WestConnex M4-M5 Link

Rozelle Interchange - Modification: The Crescent overpass and active transport links

Design amendment report

April 2020

Figure 1-1 The revised design

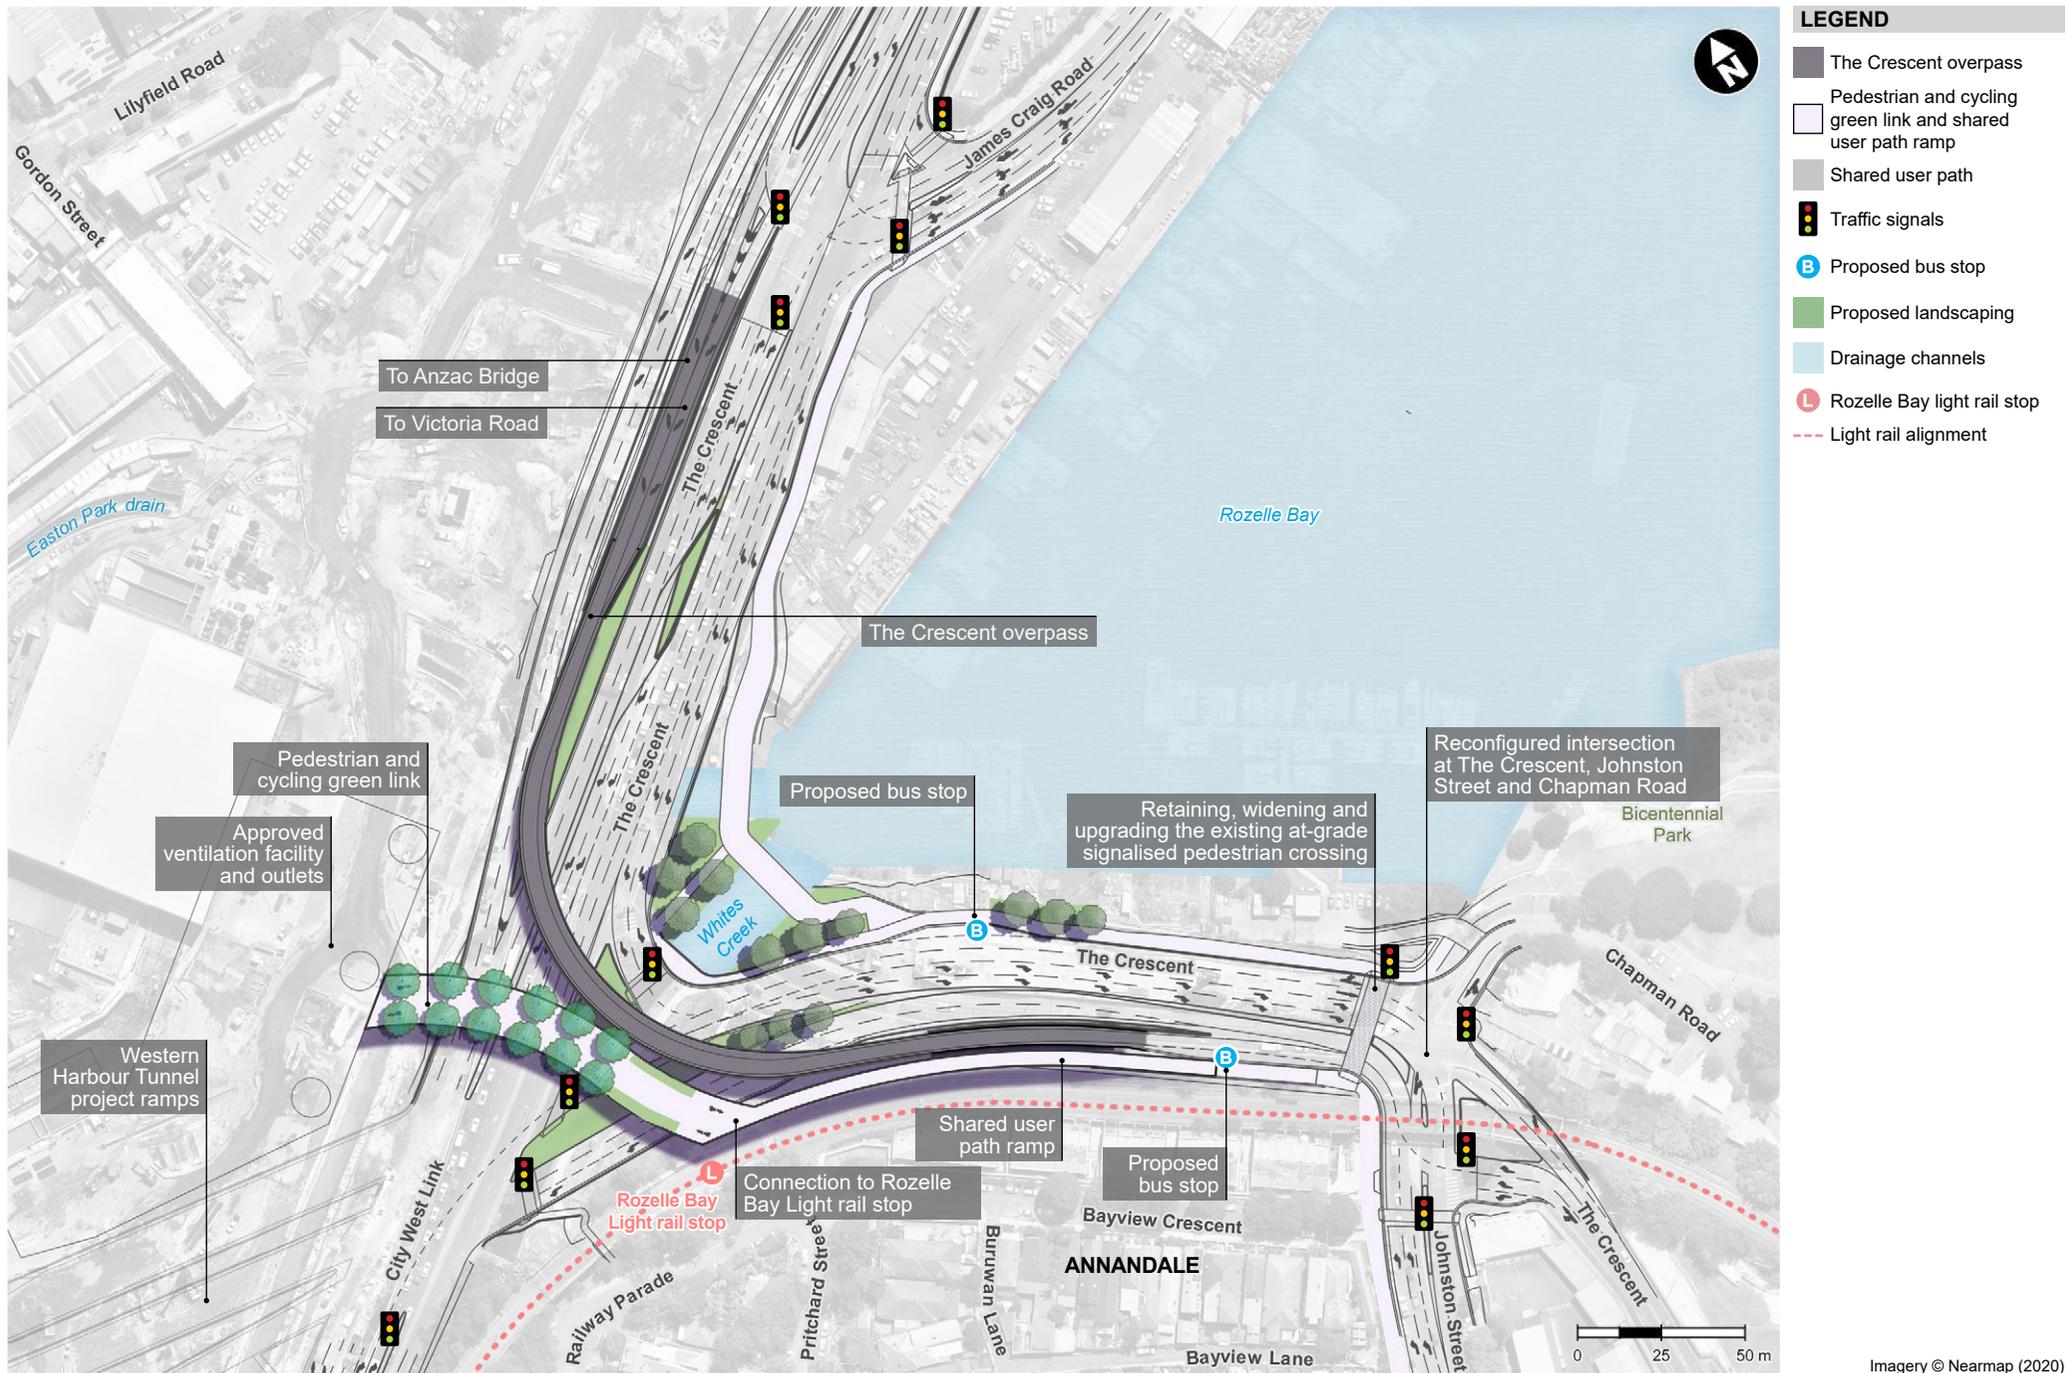
In response to some of the issues raised in submissions, Transport for NSW is proposing a number of design changes (the revised design) to achieve improved connectivity, visual amenity and urban design outcomes. These design changes include:

The revised design is presented in **Figure 1-1** and **Figure 1-2**, with a full description of the revised design and associated environmental assessment is provided **Section 2** and **Section 3**.

Figure 2-1 The revised design - the overpass (long section)

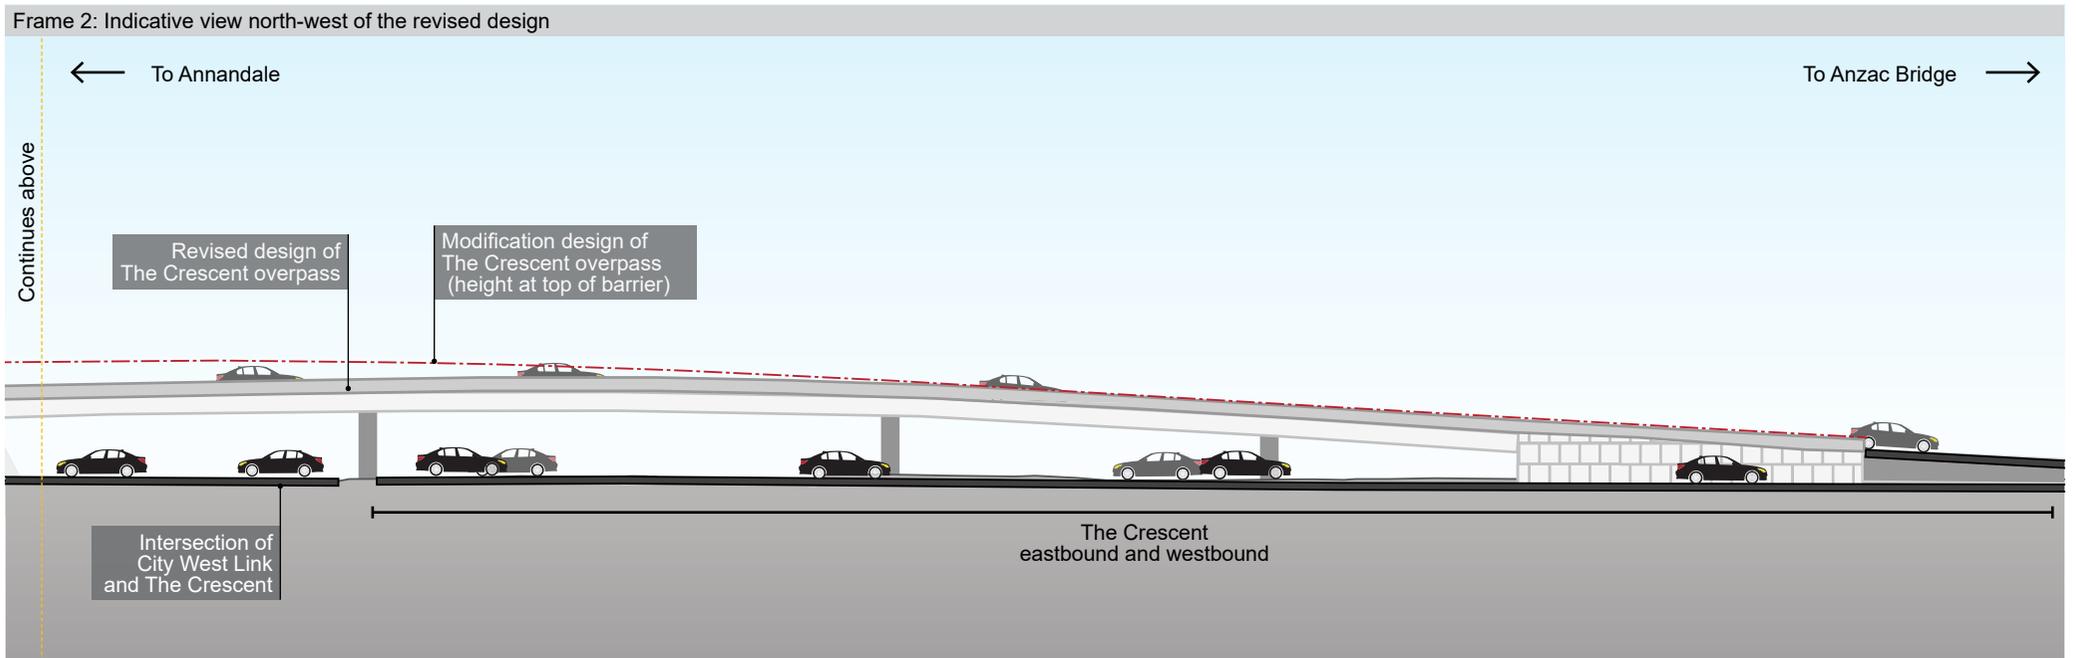
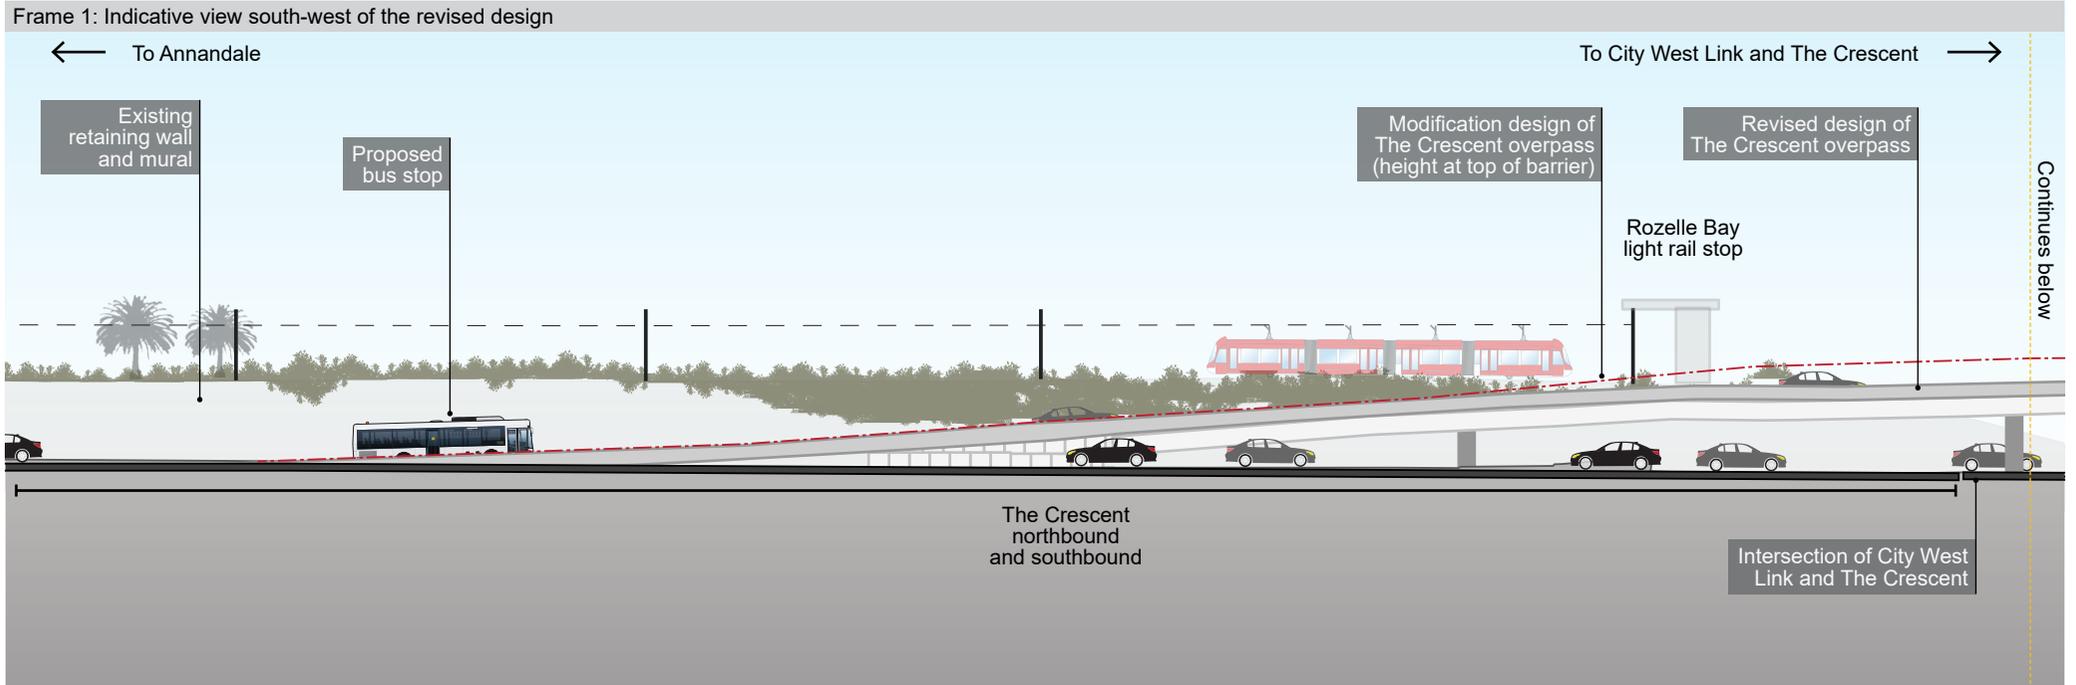
The design of the overpass has been revised to reduce the height of the structure by approximately two metres at its apex. The overpass road surface would be around nine metres above ground (maximum of around 10 metres with barriers), which is a similar to the height of the adjacent green link over City West Link. The overpass will have a minimum clearance of around six metres. The length and grade of the overpass ramps remain unchanged.

Lowering the height of the overpass would reduce the visual impact of the structure and improve the amenity and outlook for pedestrians and cyclists using the green link in an easterly and north easterly direction toward Rozelle Bay, Anzac Bridge and the city skyline. An elevation view of the overpass is shown in **Figure 2-1**.

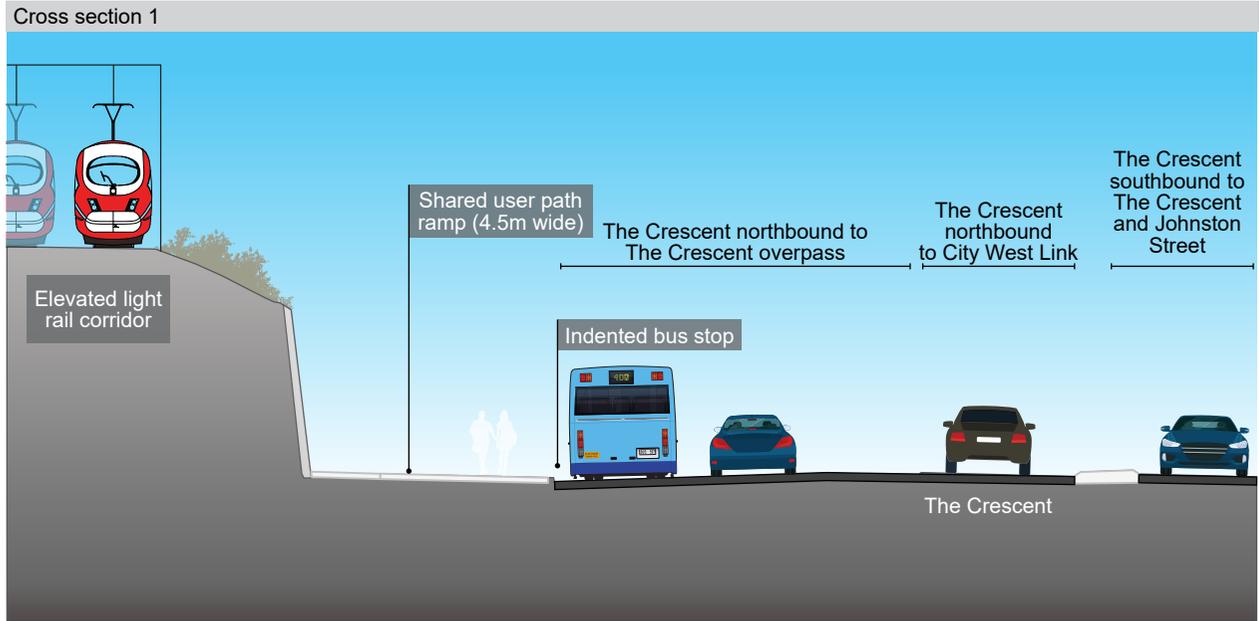
It is proposed to revise the design of the southern section of the green link to improve its interface with the Rozelle Bay light rail stop.

As a result, the green link ramps down at its southern end to meet the light rail platform and this southern section of the structure is not able to provide the necessary soil depth required to support the continuation of tree planting across the full length of the bridge.

Transport for NSW is considering a number of improvements to the appearance of this section of the green link to ensure it integrates appropriately with the remainder of the green link and the Rozelle Bay light rail stop. Options being considered include landscape plantings in raised planter beds, enhanced paving treatments and sculptural elements.

The final design for the green link will be refined during the completion of the UDLP as required by Conditions E133 and E134.

Figure 2-2 The revised design - cross sections 1 & 2

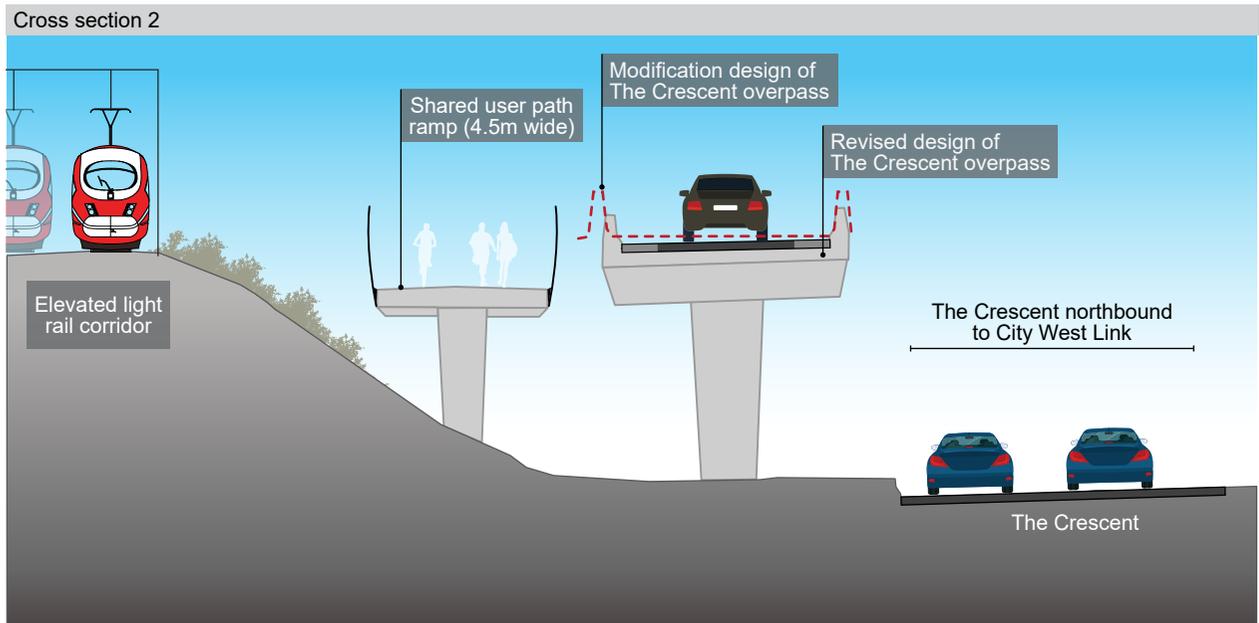
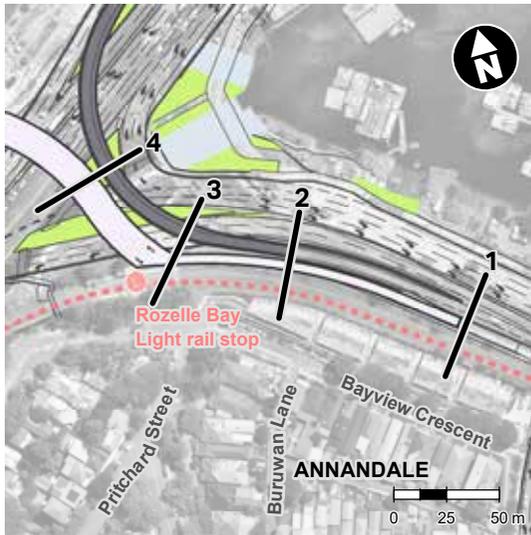
The shared user path ramp becomes an important part of the active transport connection proposed between the Rozelle Rail Yards open space, Rozelle Bay light rail stop, the west side of The Crescent and Chapman Road and the Rozelle Bay foreshore. It has been widened to accommodate the increased number of pedestrians and cyclists who are likely to use this route. Cross sections of the shared user path ramp and overpass are shown in **Figure 2-2** and **Figure 2-3**.

Figure 3-1: Revised design - pedestrian and cyclist active transport connections

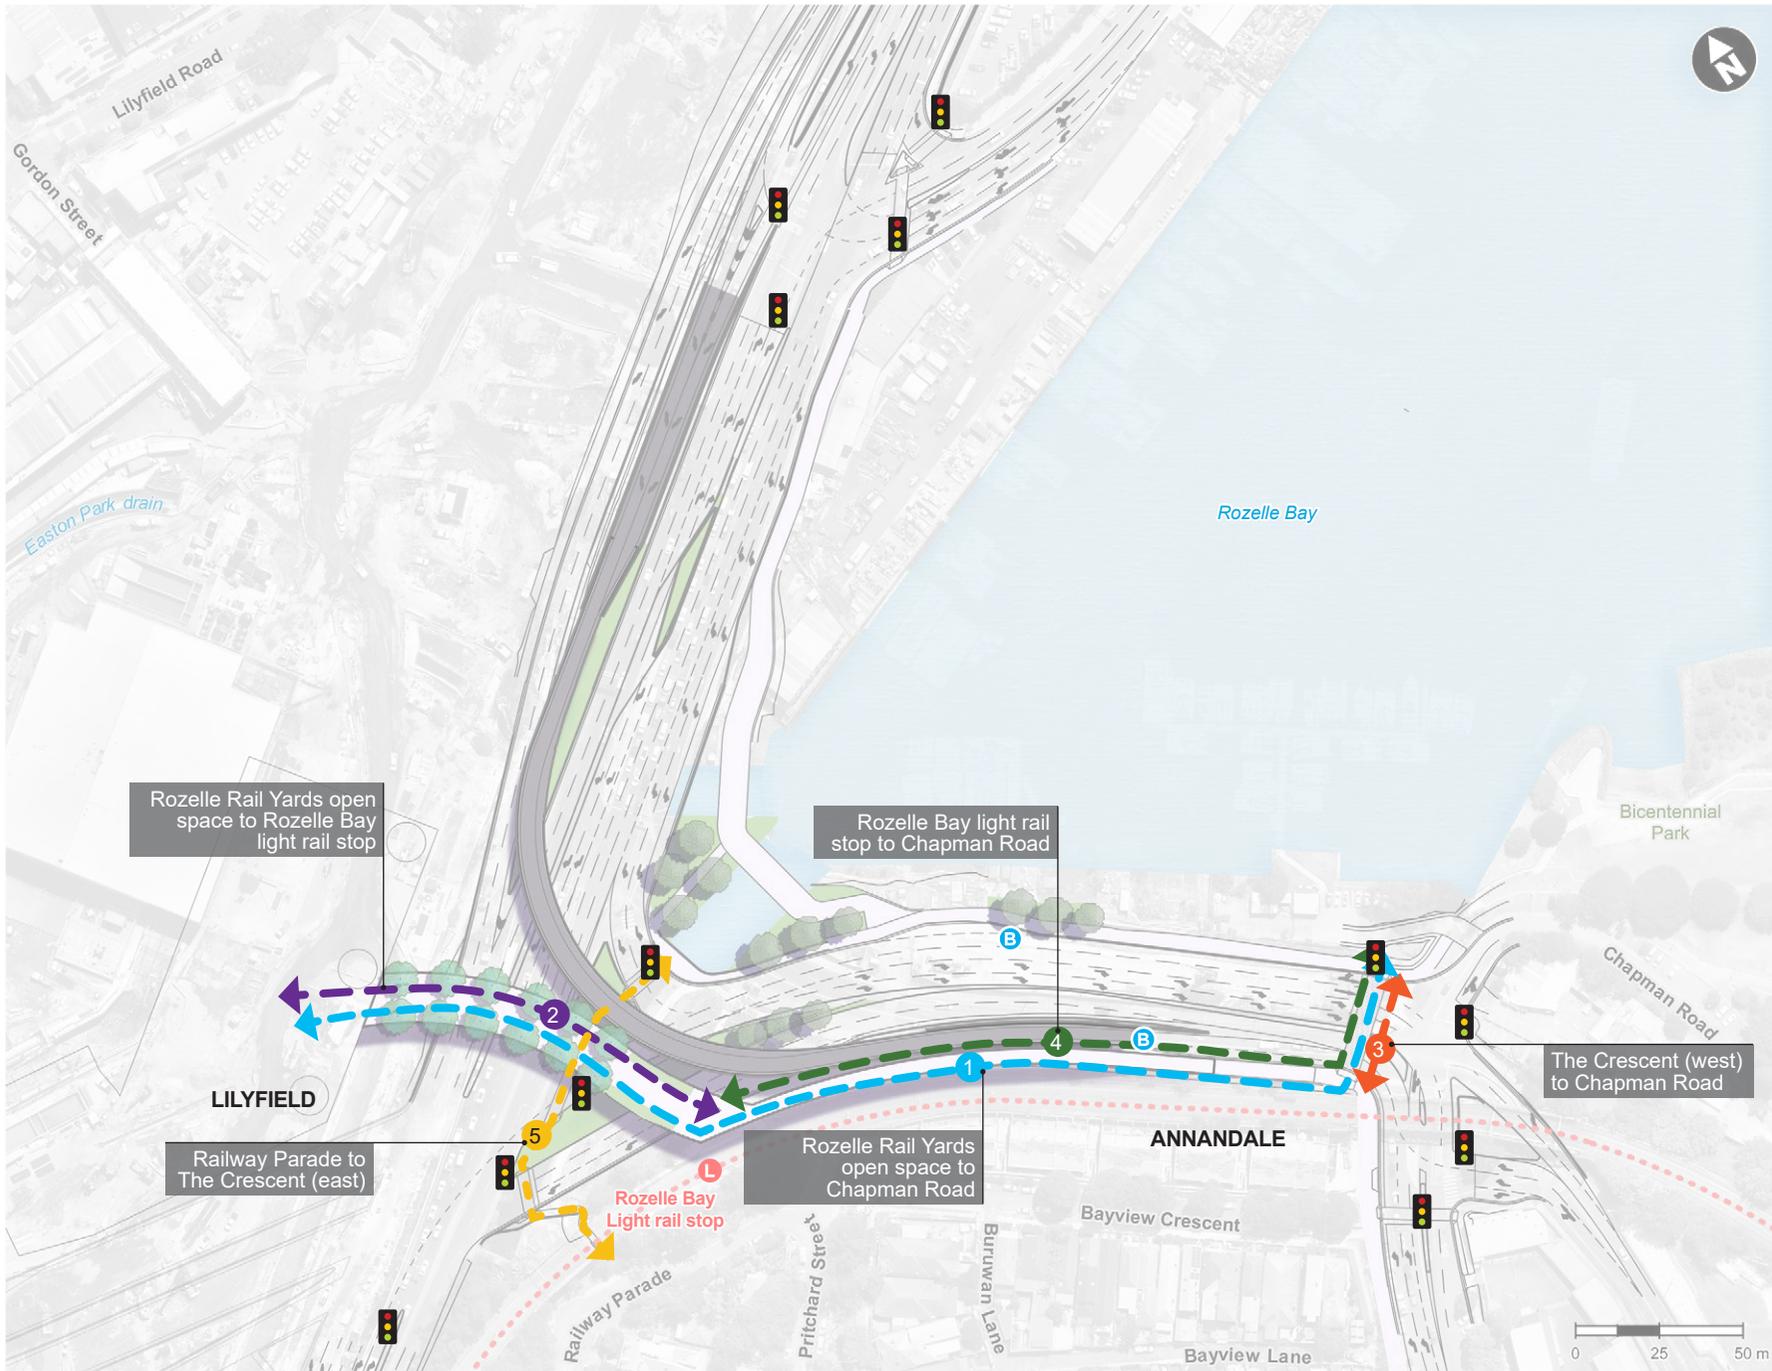
Figure 3-1 shows the different sections of the active transport connections between the Rozelle Rail Yards open space and Chapman Road which include:

The “Route 1” connection (Rozelle Rail Yards open space to Chapman Road) as shown in the EIS is no longer proposed as a result of the introduction of the overpass. To identify the travel distance and time taken for the equivalent route for the revised design, “Route 2” and “Route 4” have been combined. On that basis:

- The revised design would take five minutes and 56 seconds over a distance of 365 metres, with pedestrians and cyclists negotiating one at grade signalised crossing of The Crescent
- The EIS design would take four minutes and 14 seconds over a distance of 330 metres with no signalised crossings required.

Although the revised design would result in a longer travel time than the EIS, the revised design is an improvement over the arrangement proposed in the modification, which included the longer route of the shared user path bridge.
